UNITED STATES PATENT AND TRADEMARK OFFICE

09/848,819

Office Action Summary

DETAILED ACTION

FIG. 4B

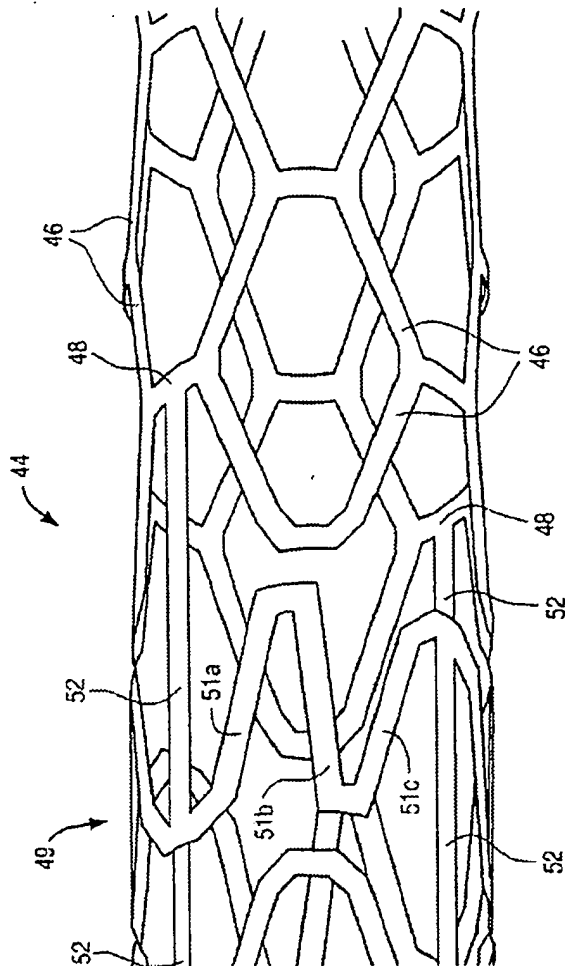
3. Claims 26,29,31,32,33,34 are rejected under 35 U.S.C. 102(e) as being anticipated by Klein US PN 5,593,442.

See figure 4B (as detailed on page 4 of the last office action) below specifically showing location of the cylindrical rings, reinforcing members, and interconnecting

members. Also see abstract and lines 61-64 of col. 4 incorporating US PN 5,102,417, which discloses in lines 3-34 of col. 11 coatings for stents.
